RECEIVED
 OK'D BY: *[Signature]* DATE: *12/12/06*
 DEC 05 2006
 RESUBMIT APPROVED
 BY: *apw* DATE: *12/12/06*

PIKE INDUSTRIES
 VT RTE 8, RURAL MAJOR COLLECTOR
 READSBORO, VT

STATIONING AND FOOTING PLAN - BRIDGE NO. 02
 Drawing No. C18331-L01-2

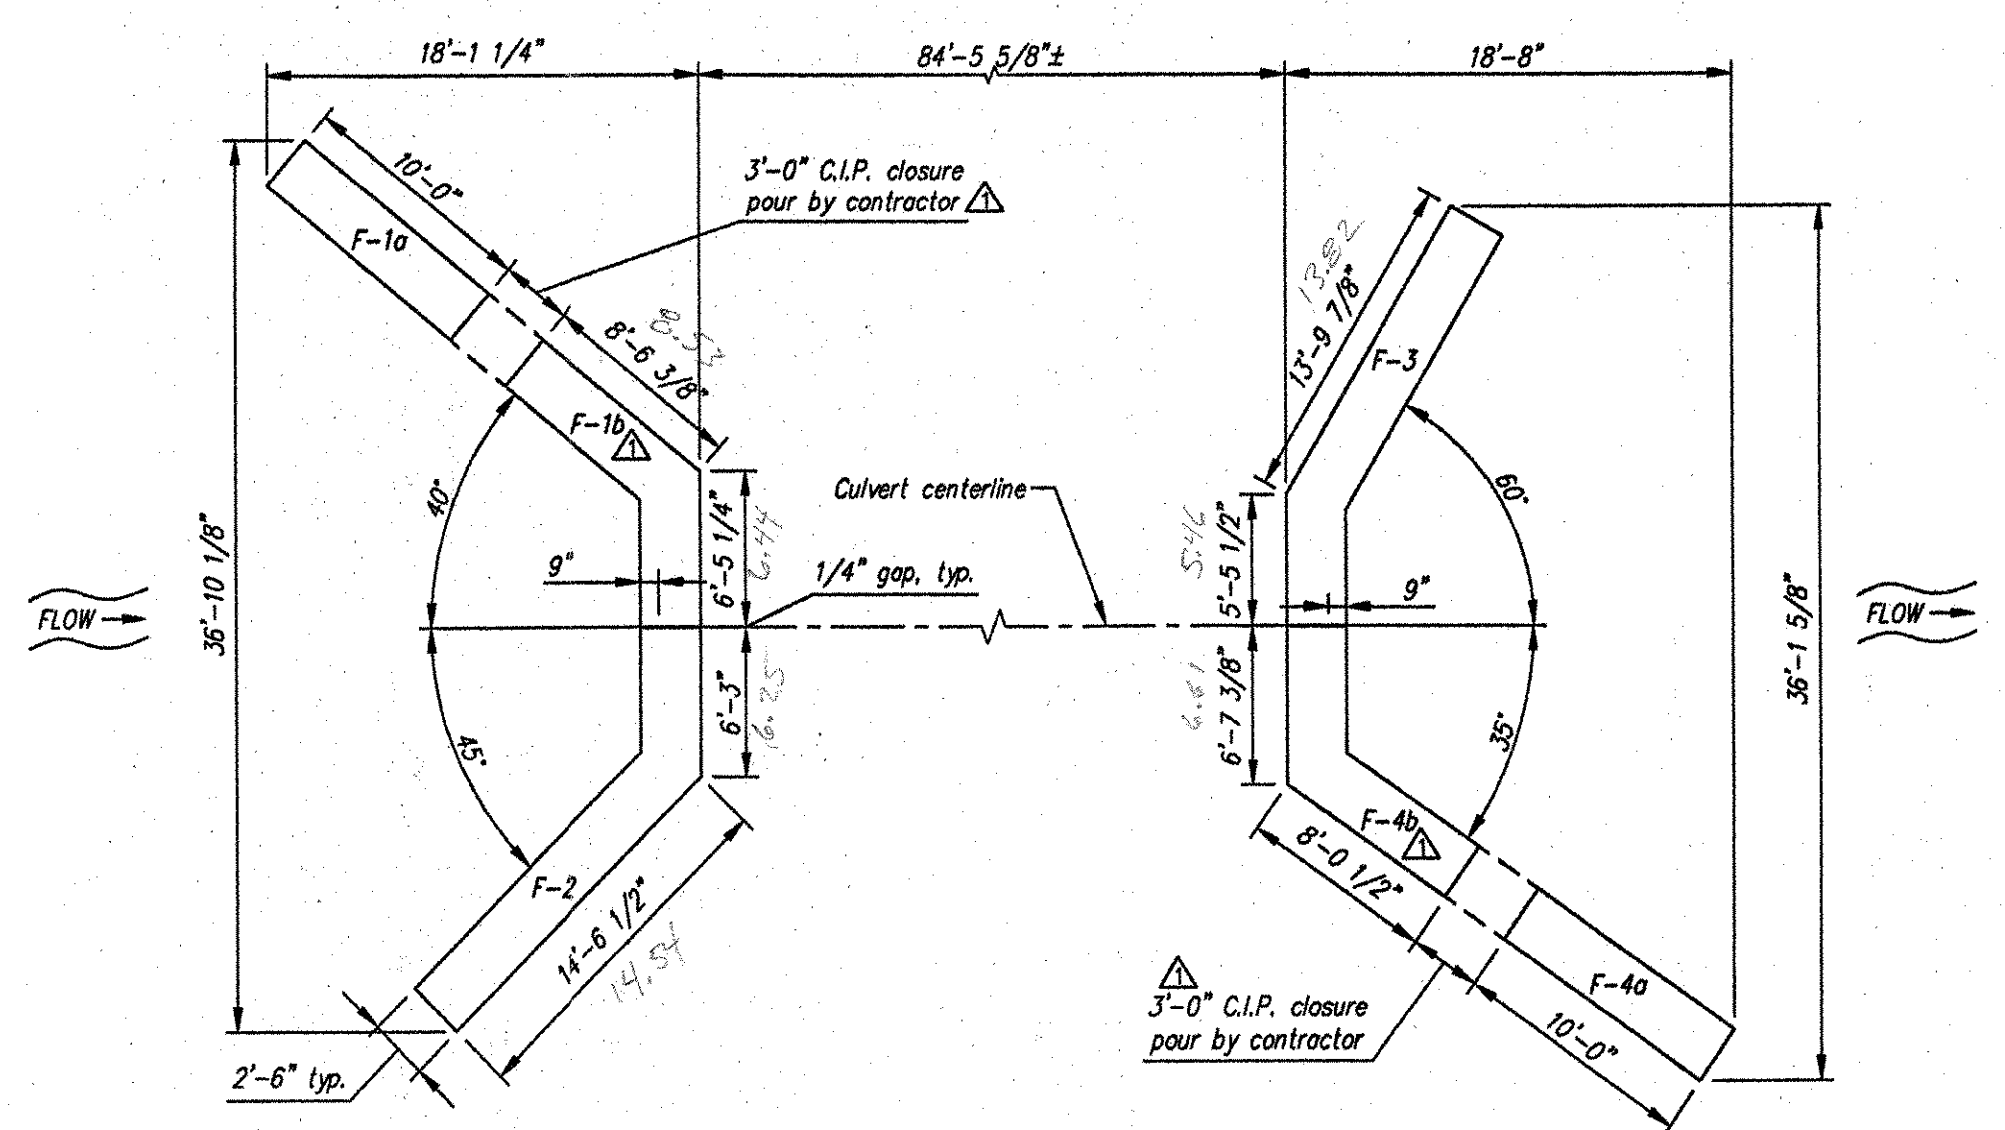
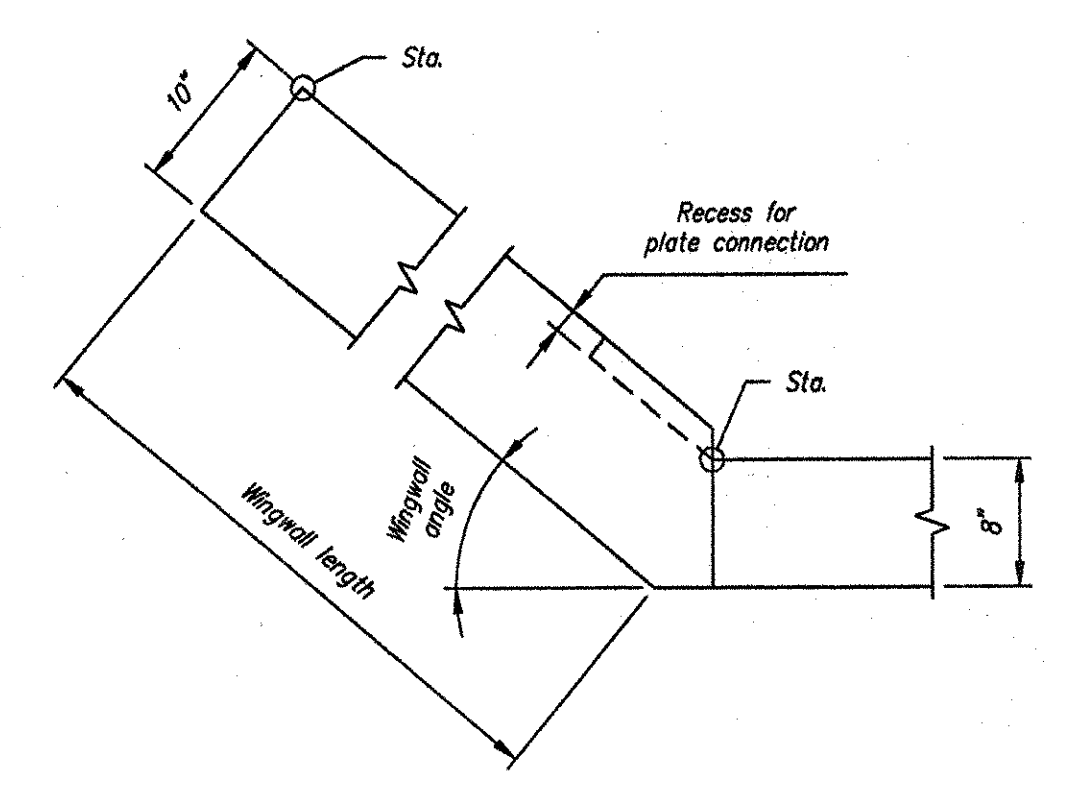
Rev.	Date	DESCRIPTION	By
5			
4			
3			
2			
1	11/21/06	Added dimensions to wingwall stations and C.I.P. curb; Revised Footing Plan	MS
